Docket Item # 7 & 8
BAR CASE # 2010-0061/0062

BAR Meeting
May 5, 2010

ISSUE: Permit to Encapsulate & Addition

LOCATION: 907 South Saint Asaph Street

Figure 1: : Survey of 907 South St. Asaph Street, with new porch shown.

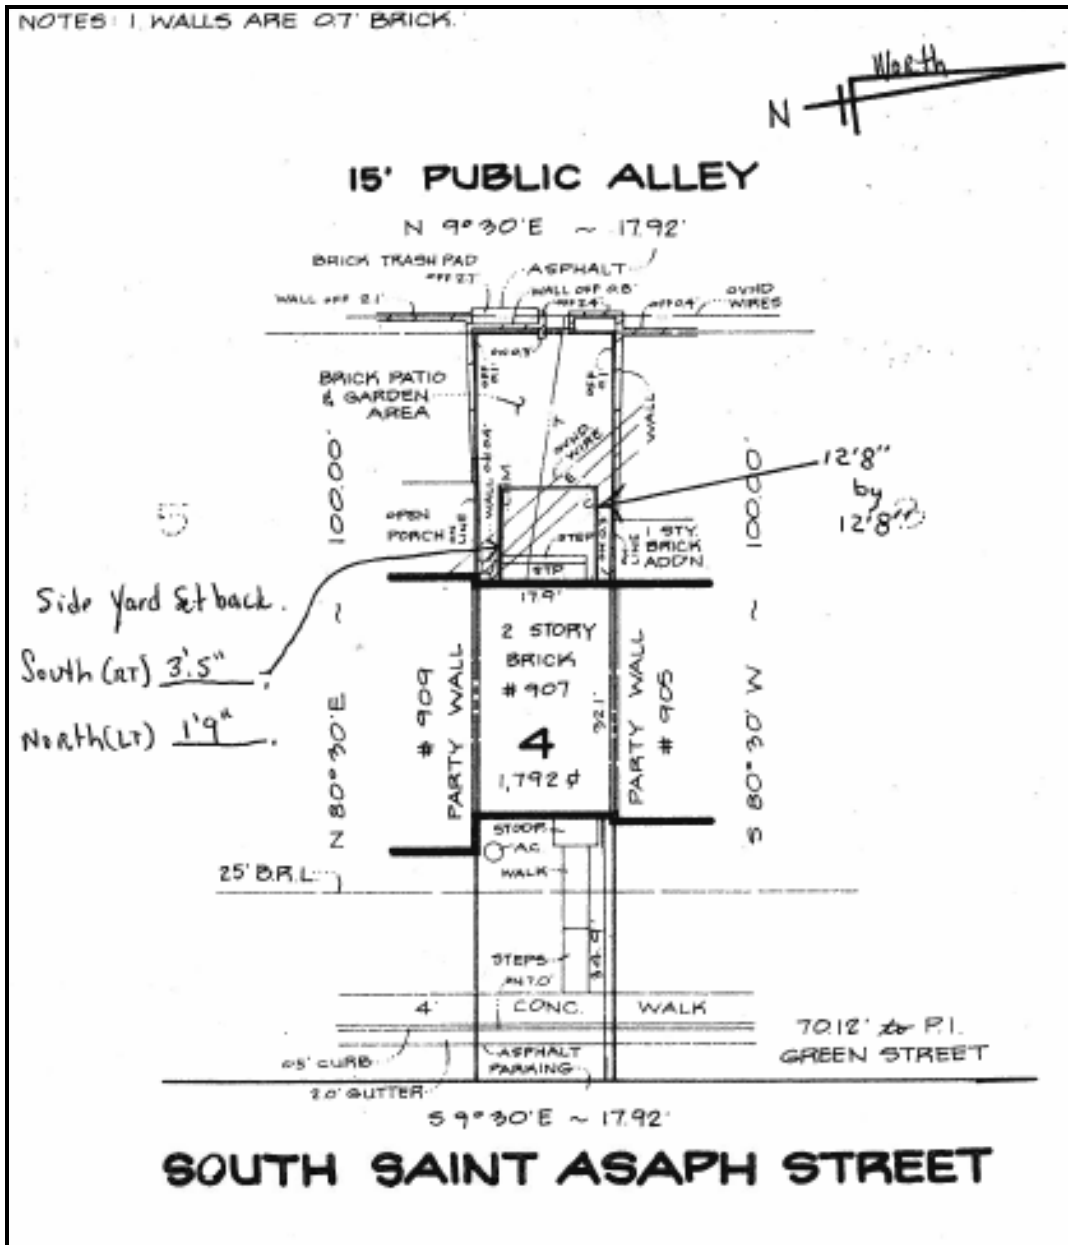
The proposed enclosed porch complies with the RM zone as defined in the City's Zoning Ordinance. The RM zone requires that the lot provide a minimum of 35% open space or 627.2 sq ft. The lot currently provides 1159.41 sq ft or nearly 64% open space, and will provide 994.57 sq ft or 55% open space after construction of the proposed porch.

Figure 4: Section of Proposed Porch Addition

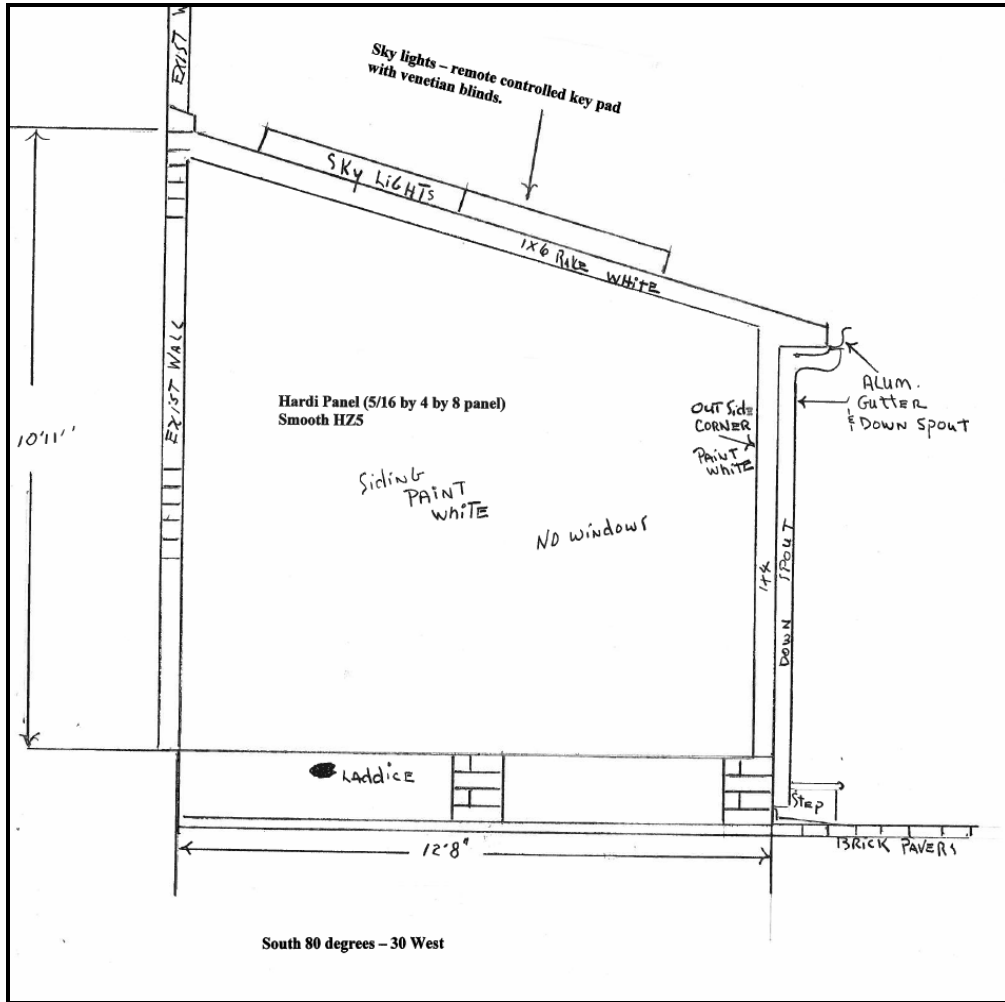
The applicant also proposes to install diagonal lattice under the porch. Staff recommends that the

lattice be constructed in a horizontal and vertical configuration, rather than diagonally as horizontal and vertical lattice is the more typical historic lattice configuration in the district and the configuration referenced in the *Guidelines* and that the Board generally approves. Staff is including this as a suggestion rather than a condition since it appears that the lattice will not be visible from the public right-of-way over the existing brick garden wall fence and solid wood gate.
